UNITED STATES
DEPARTMENT OF THE INTERIOR
BUREAU OF LAND MANAGEMENT

FORM APPROVED
OMB No. 1004-0137
Expires: July 31, 2010**SUNDRY NOTICES AND REPORTS ON WELLS**
Do not use this form for proposals to drill or to re-enter an abandoned well. Use Form 3160-3 (APD) for such proposals.5. Lease Serial No.
NM 12764

**Lonesome Dove 25 Fed 1
Eddy County, New Mexico
10/2013 Current Wellbore
30-015-31698**

**Lonesome Dove 25 Fed Com 1
30-015-31698
Rubicon Oil & Gas, LLC
February 07, 2014
Conditions of Approval**

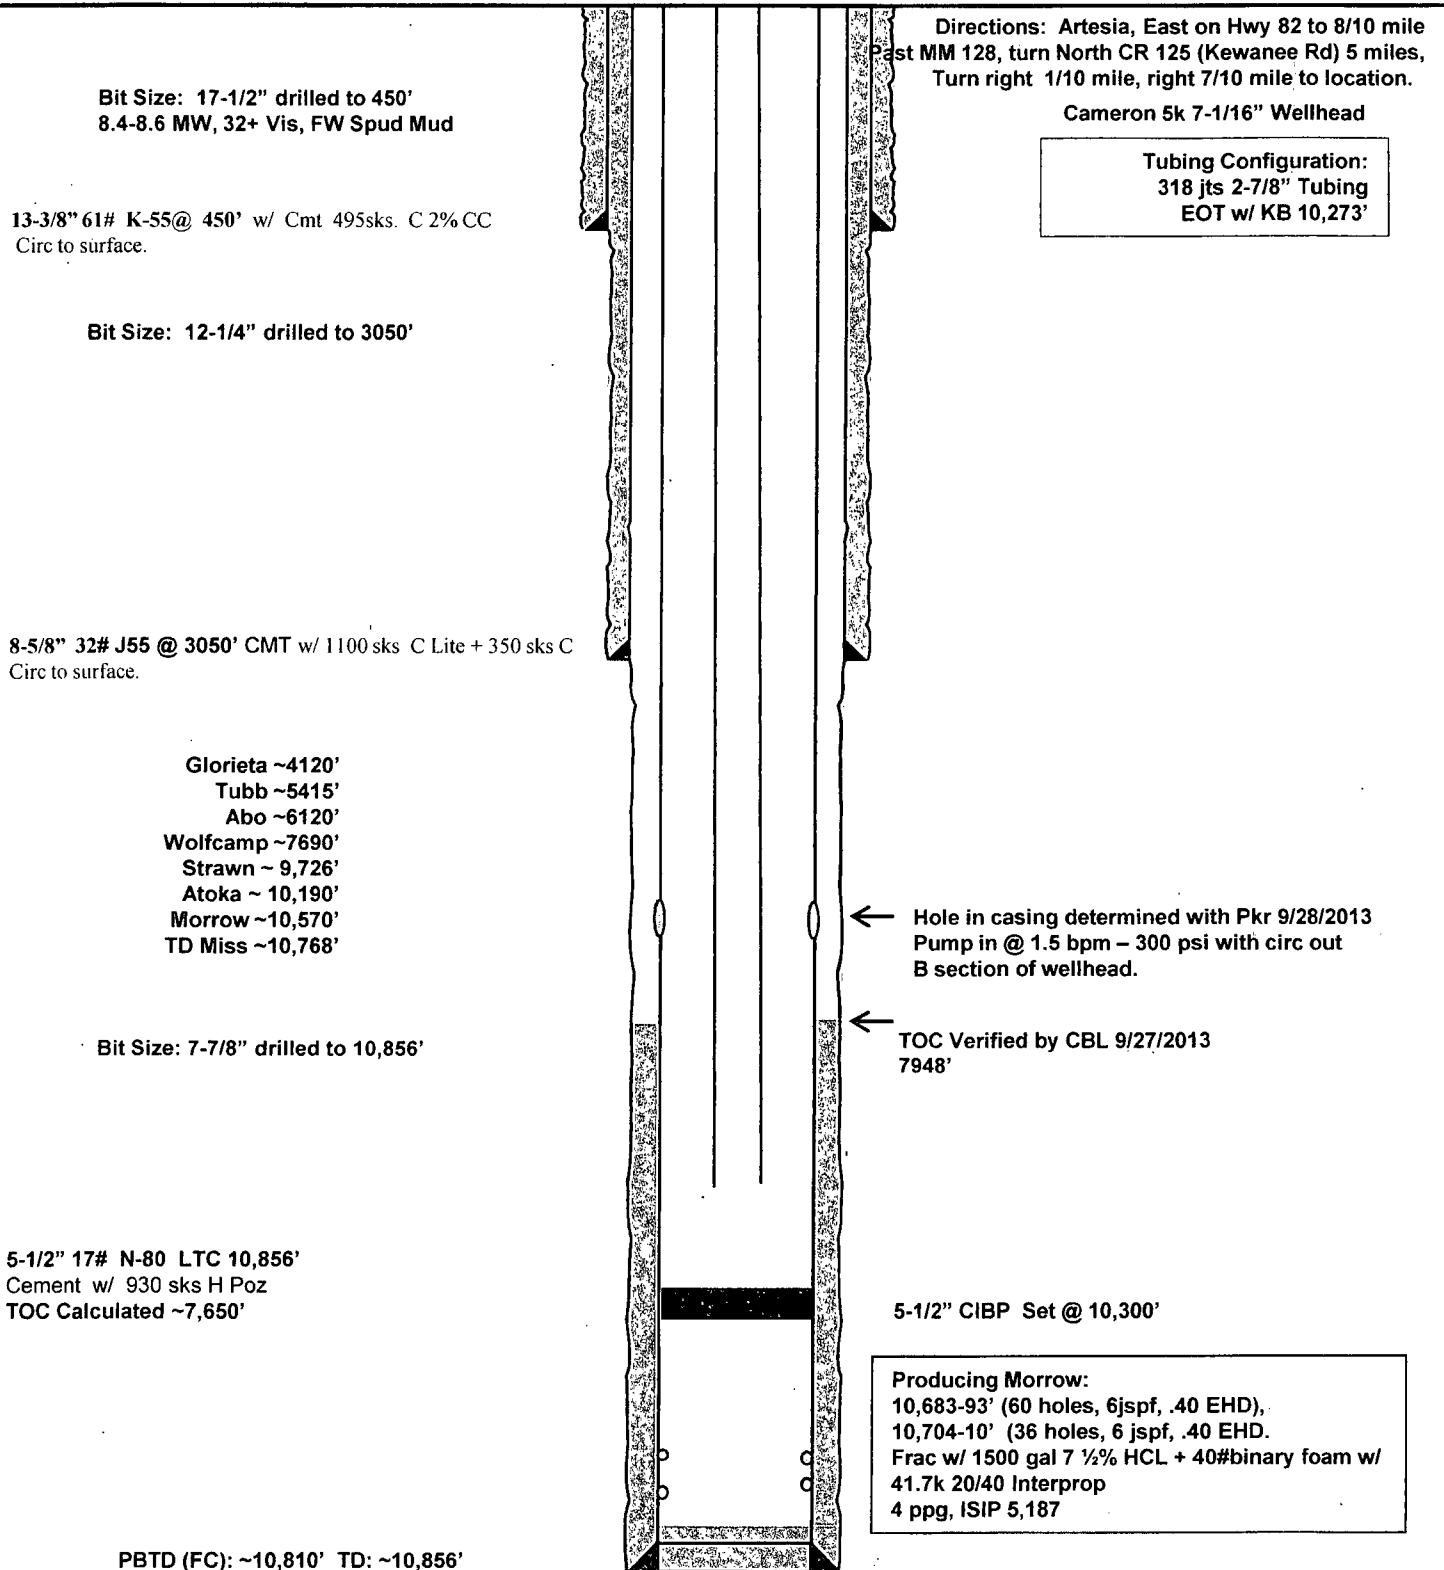
must run OBL & discuss w/ BLM engineer prior to recomplete
Provide C102

- 1. Operator shall drill out the CIBP at 10,300' as they did not follow the COAs.**
- 2. The operator shall place CIBP at 10,633' and place a 206' Class H Cement plug (minimum of 25 sx) on top.**

- 3. Operator shall perf and squeeze Class H Cement at 7740' and tag cement at 7600' or higher to ensure the isolation of the top of the Wolfcamp formation.**

- 4. Step 5 is approved as written. Prior to recompleting into the Yeso formation a CBL must be run and e-mailed to jamason@blm.gov and TOC shall be discussed before operator has approval to recomplete.**
